# **Campus Planning Committee Presentation**

February 16, 2012

# University of Oregon Student Recreation Center Addition Creative Brief

# CPC Discussion Points & Response

# East Elevation

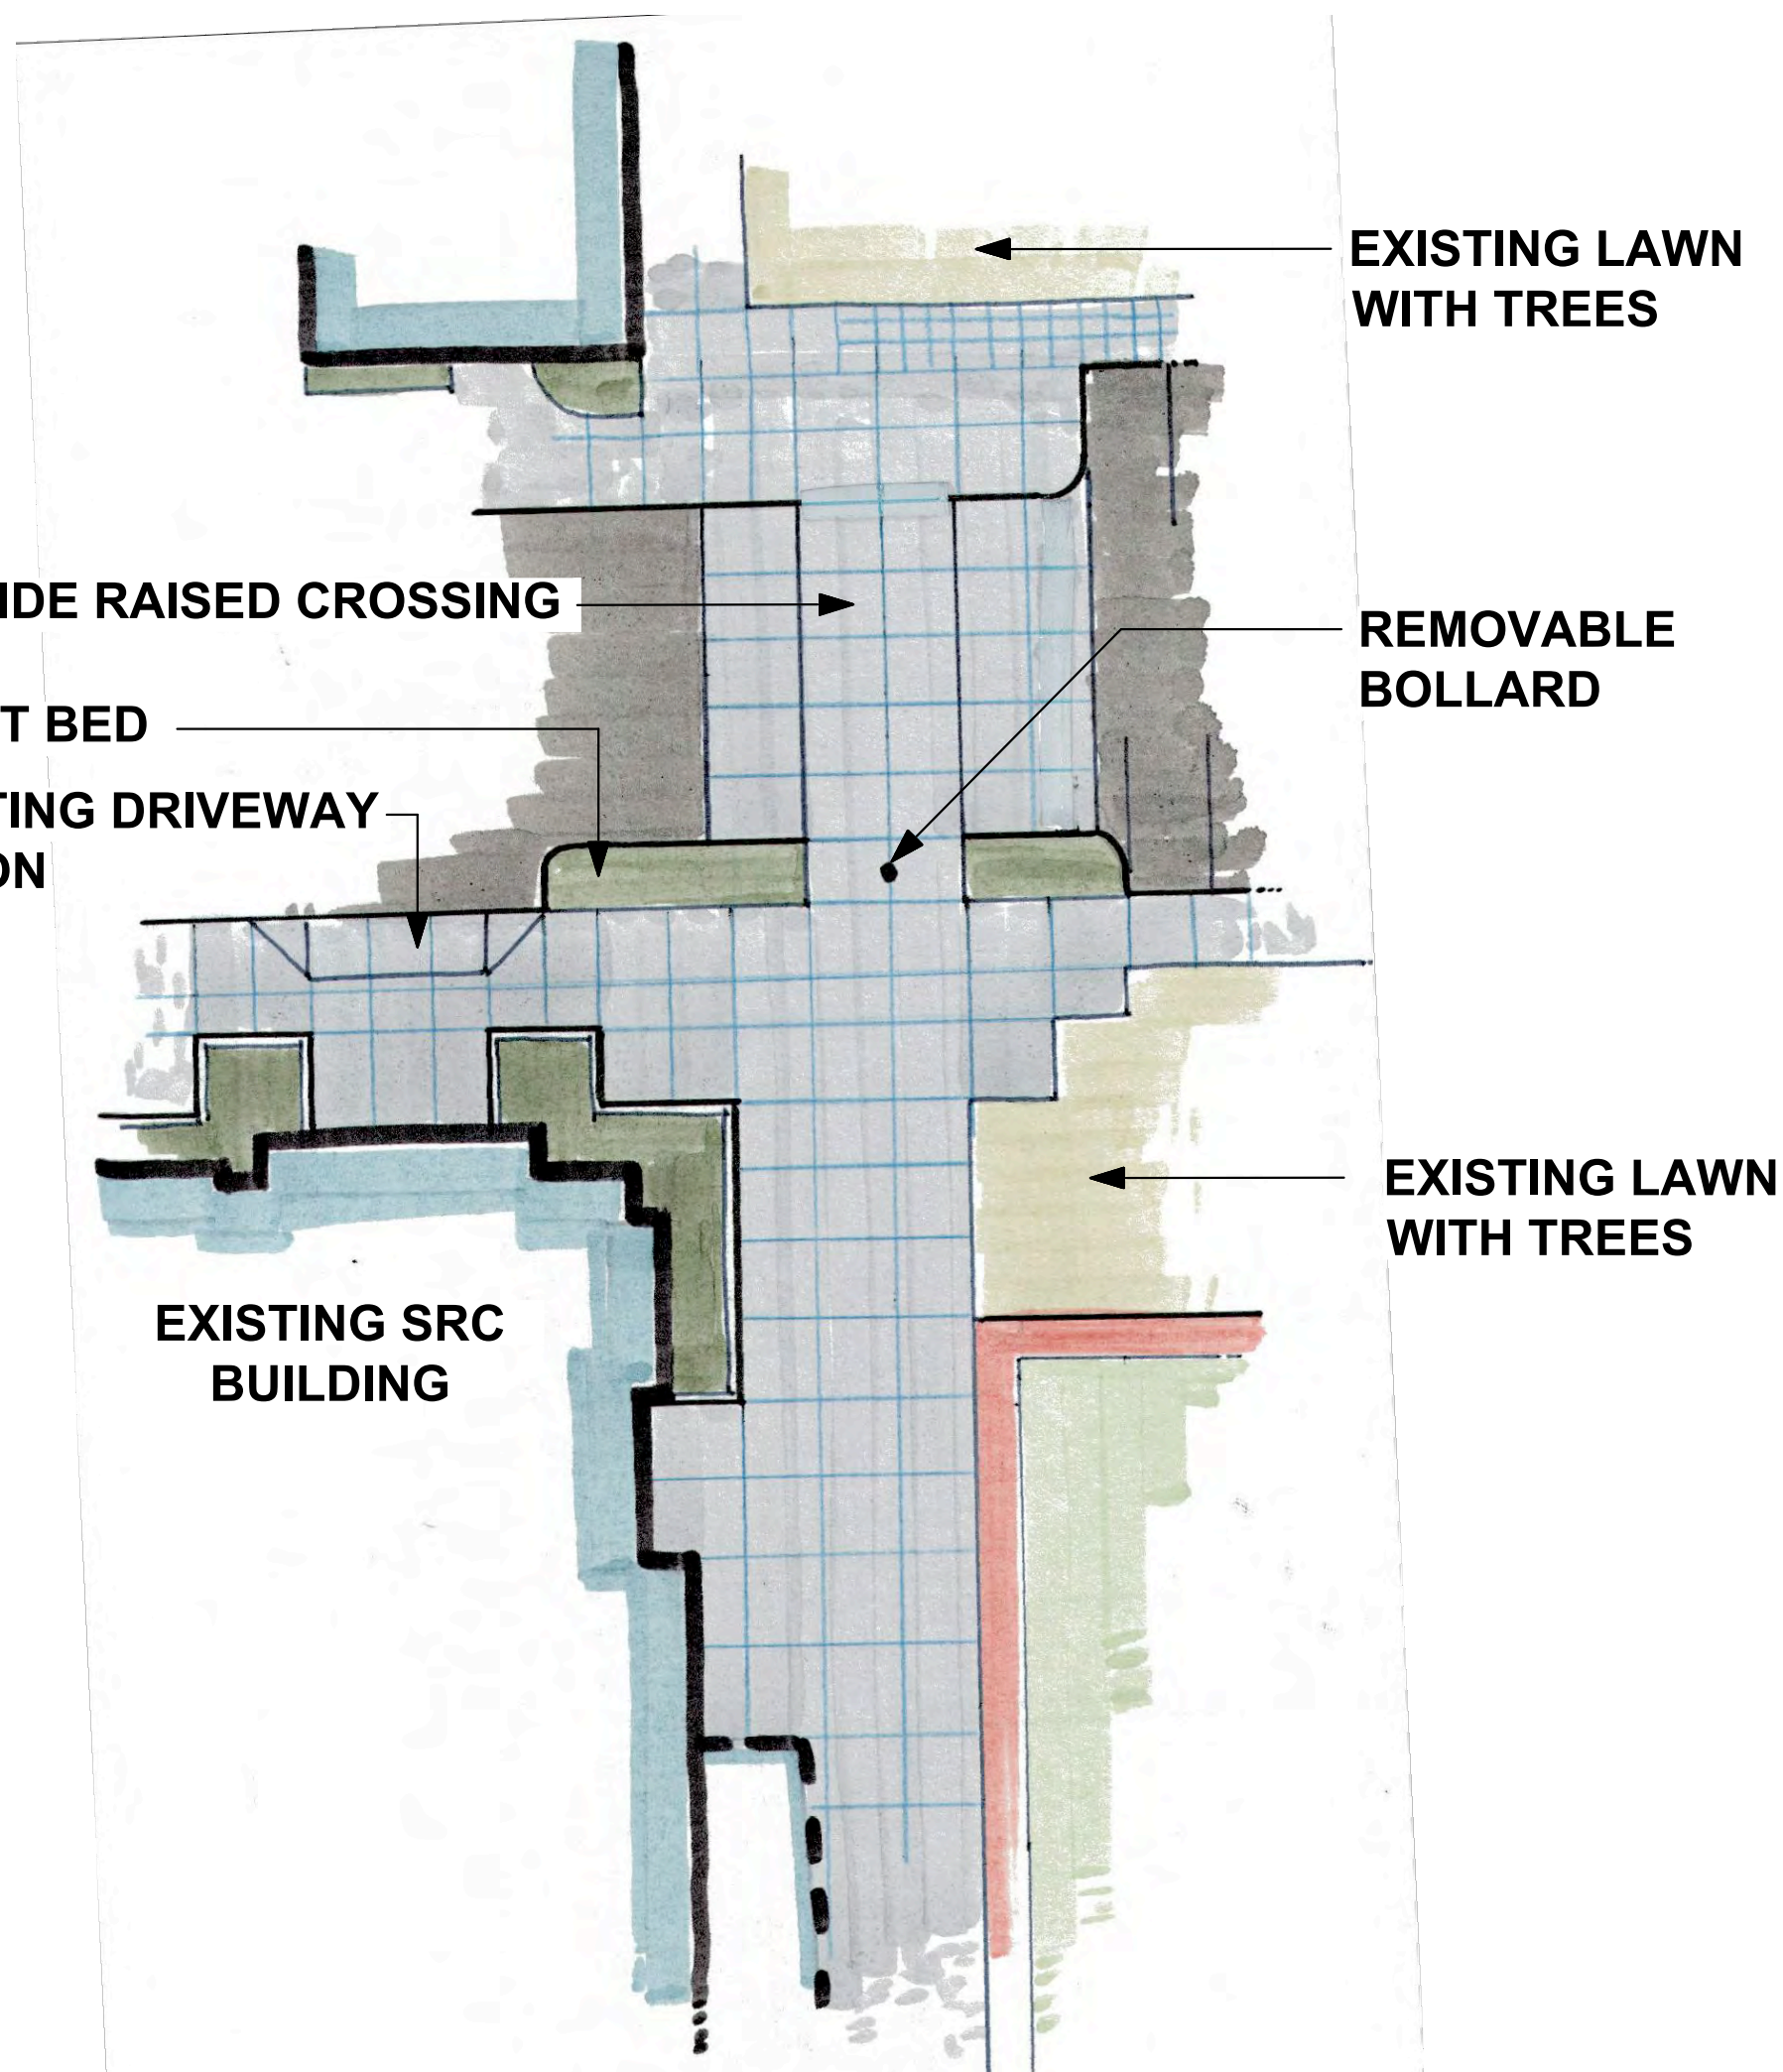
•Better define the east entry; the proposed deep recess is not adequate.

•Ensure that the east façade fits into the fabric of the campus’s design and function. As designed, the proposed shape is not found on campus. Use the existing 15<sup>th</sup> Avenue façade as an example of how the design should connect to the broader campus and Esslinger Hall thru the use of materials, a main entry, façade definition, and roof shape.

•Reassess the design and function of the east façade’s angled cantilever of the pathway. As designed, it does not seem to relate to the fabric of campus, and it only partially covers the proposed seating area. Recognize the range of important function the covered space serves and determine how best to address the key functions (consider moving bike parking out of this area).

RESPONSE: Agreed. This entrance has been widened and improved to provide better visual access! The framed opening in the proposed design was incorporated to make strong relationships to the SRC and Esslinger while conveying an intuitive, welcoming entrance. Weather protection is afforded via overhead canopy.

RESPONSE: Understood. In this revised / proposed design you will see important new sensitivity to materials, entries, façade definition and roof shape. The 15<sup>th</sup> Avenue façade was used as a springboard for the east façade. The roof shape has been significantly modified, as requested – a flatter profile which is prominent on campus. The proposed shape is an honest expression of student use and interior activities in the building – you will see much movement inside. Precedence for this design can readily be found in campus buildings like the EMU “fishbowl” and Lillis atrium.

RESPONSE: The revised design has been crafted to reflect these concerns, while also clearly reflecting a primary goal of this project . . . An honest expression of student-centered recreational use, being something clearly distinct from primary academic space. The University has a nicely diverse palette of materials, details, and shapes upholding the Campus Character guidelines of high quality, human scale, and careful detailing. There is an opportunity in this new addition to express the student nature of this facility (a campus life facility!), while maintaining all of its other important attributes. The cantilever edge engages the east playing fields, the bike path, and focuses on the expansive view to the northeast, bookended by the Hayward Field west grandstands. In this revised design the seating area has been significantly expanded – it works much better now.
